## **CRANE STREAM AND WETLAND MITIGATION SITE**

**Response to DMS Comments**

DMS Project ID No. 100165  
Full Delivery Contract No. 0302-01  
RFP No. 16-20190302  
USACE Action ID No. SAW-2020-01401  
DWR Project No. 20201292

**DMS Comments Received (Black Text) & Responses (Blue Text)**

**FENCING PLAN**  
**L2.01**

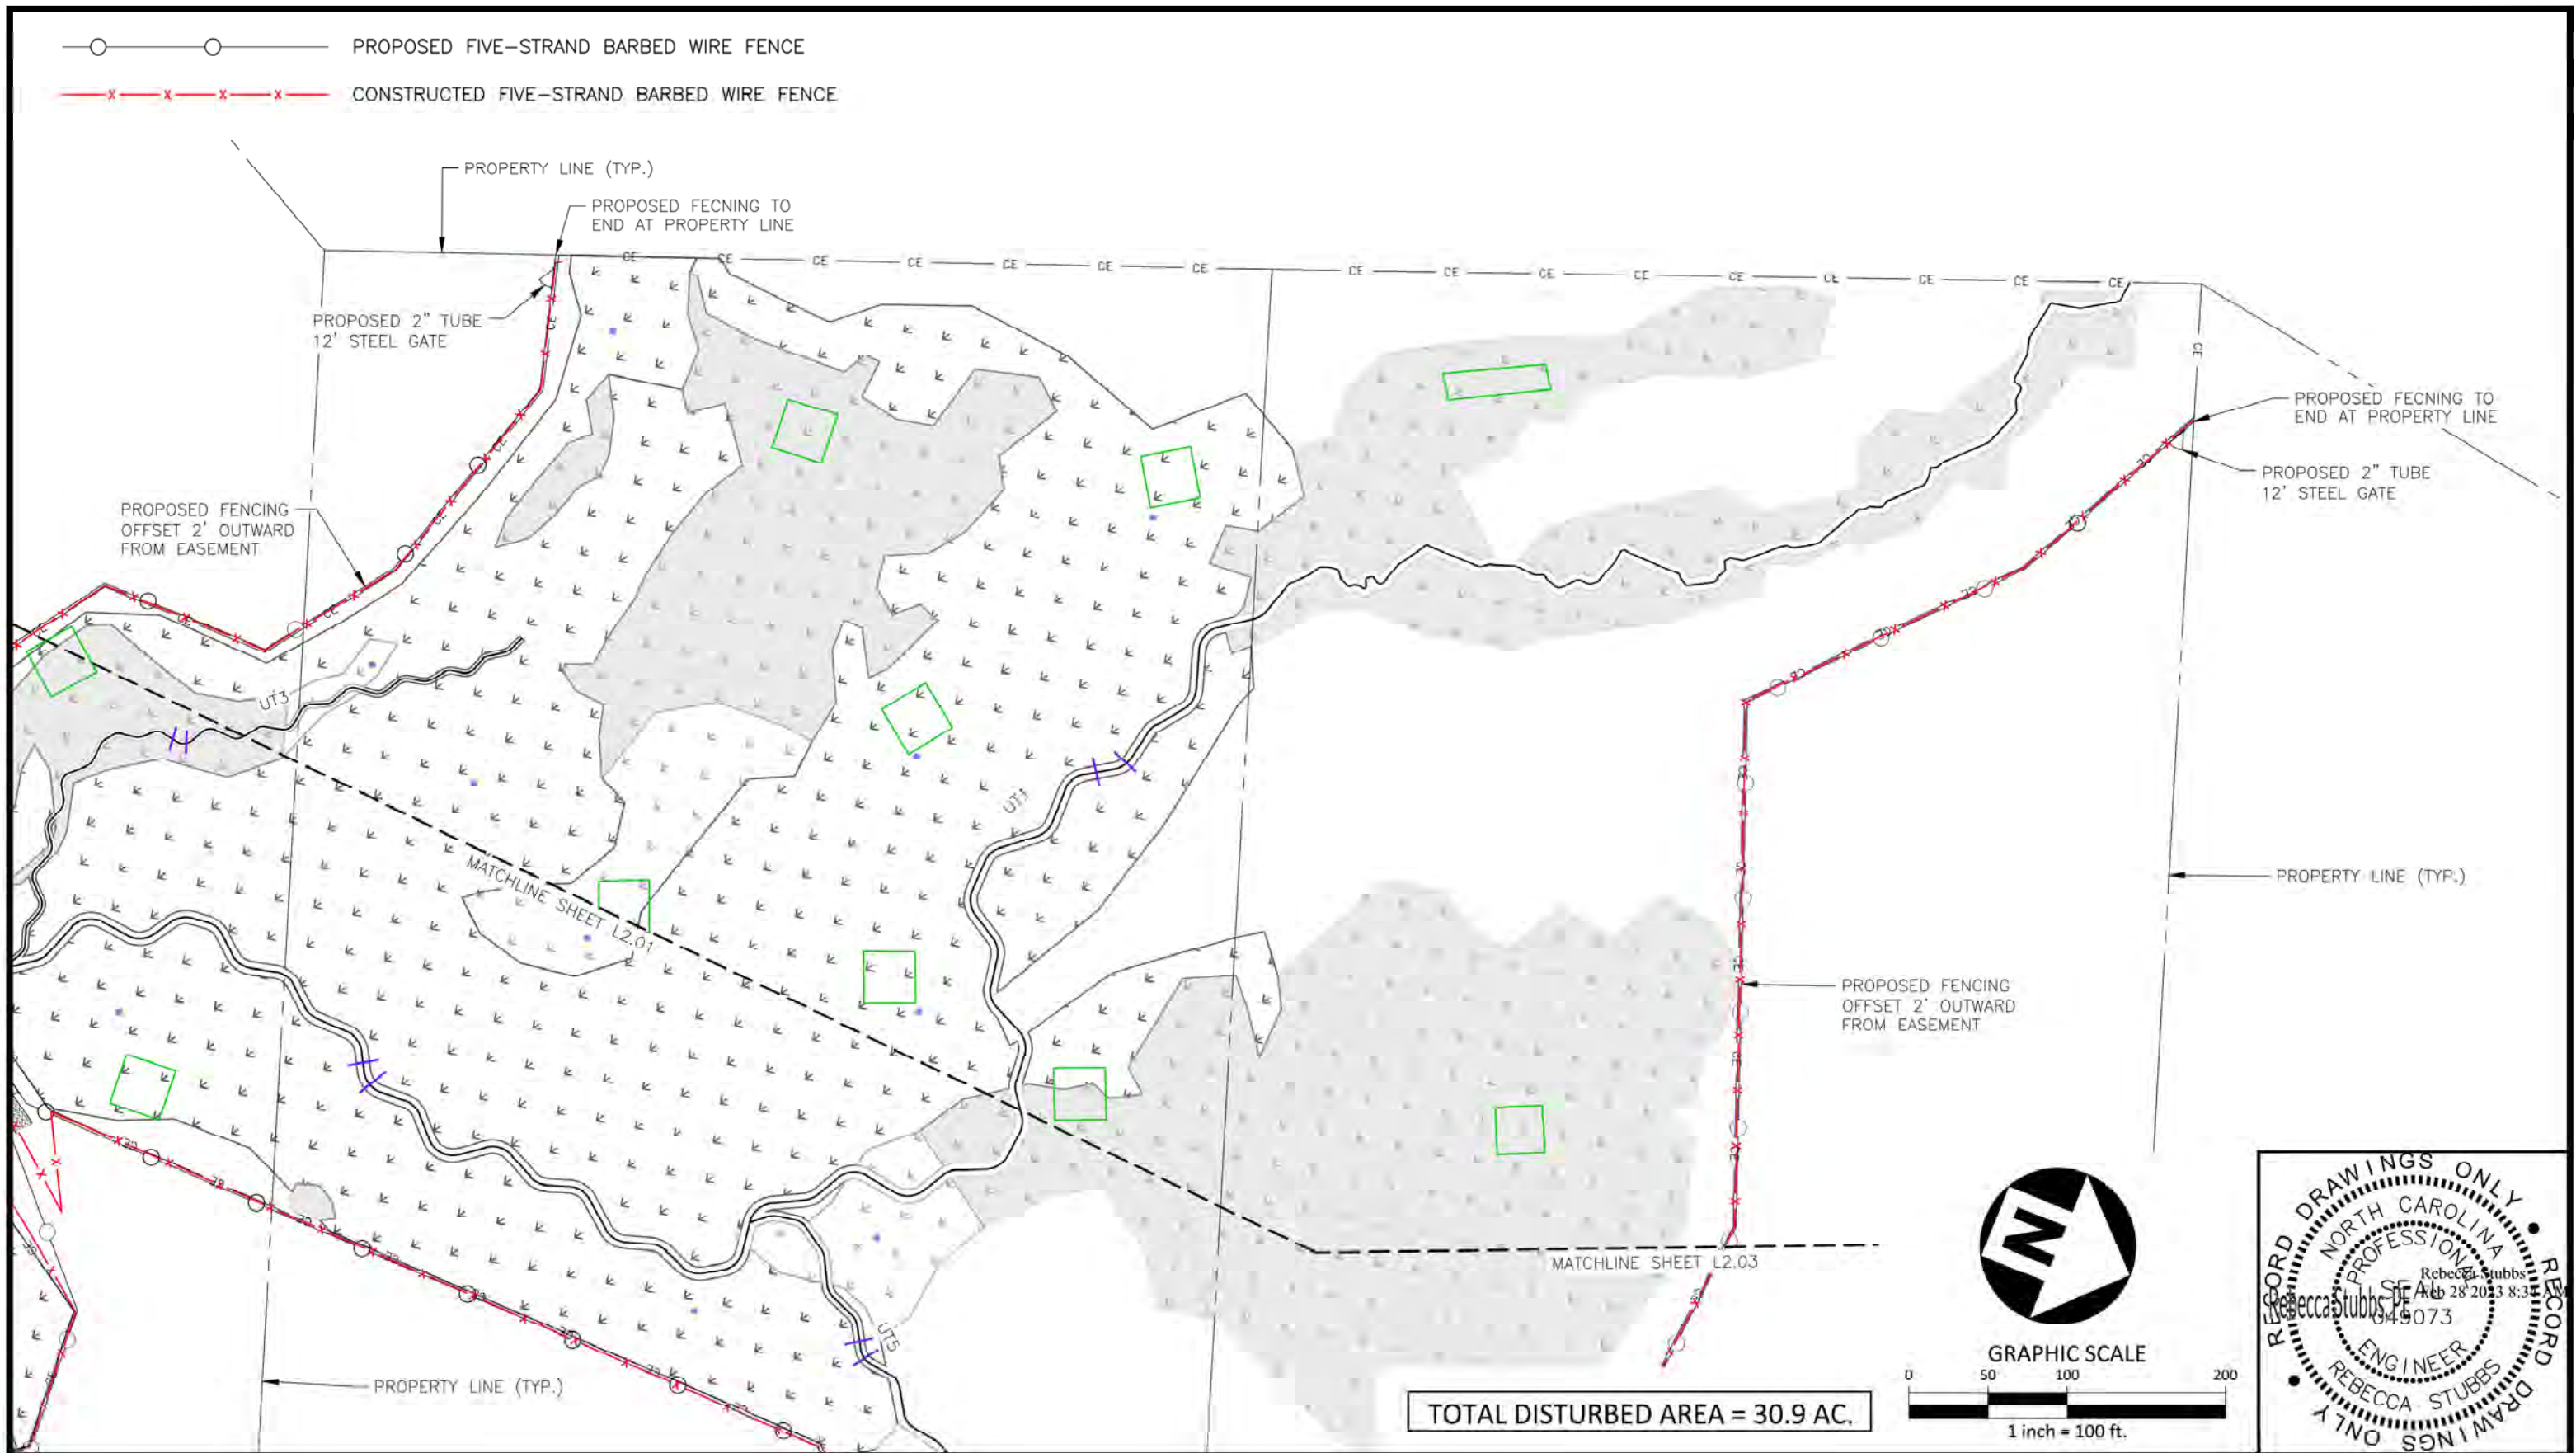
11. Sheet C5.04 & Sheet L2.01 – Gravel access path and bridge are called out in red text. Was this a construction deviation, and if so, what was the deviation? If not, recommend calling out in black.  
Callouts have been modified to appear black on paper.
